CERTIFICATE OF APPROPRIATENESS

Property: 1806 Decatur, Tracts 7A & 8A, Block 44, Baker W R SSBB Subdivision. The property includes a historic 1,285 square foot, one-story wood frame single-family residence situated on a 3,000 square foot interior lot. Remodeled c. 2008. Carport added c. 1992

Proposal: Alteration – Openings

CURRENT PHOTO (DOOR TO REMAIN/WALLED FROM INSIDE)

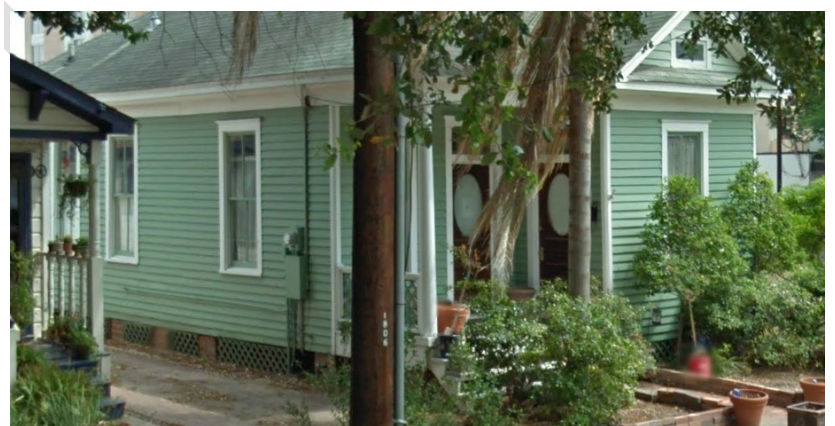
(SECOND DOOR TO BE INSTALLED ON LEFT)

PROPOSED:

New Door will go in the red block.

DOUBLE ENTRY SIMILAR TO 1804 DECATUR

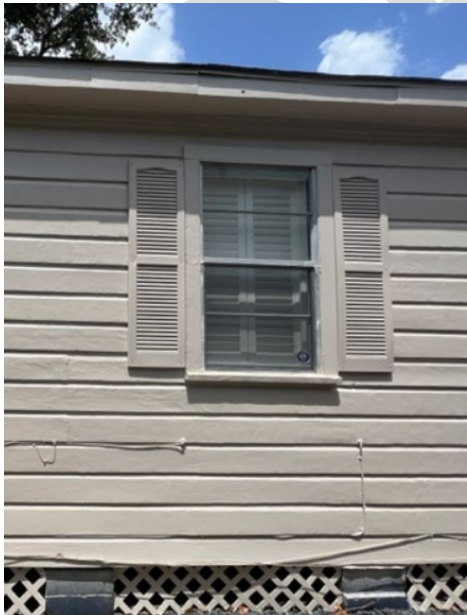
Proposed front window lite pattern matches existing noncontributing, all other windows match 1/1 simplified lite pattern currently on the home. Proposed additional front door is similar to many existing contributing structures in Old Sixth Ward with two front entrances.
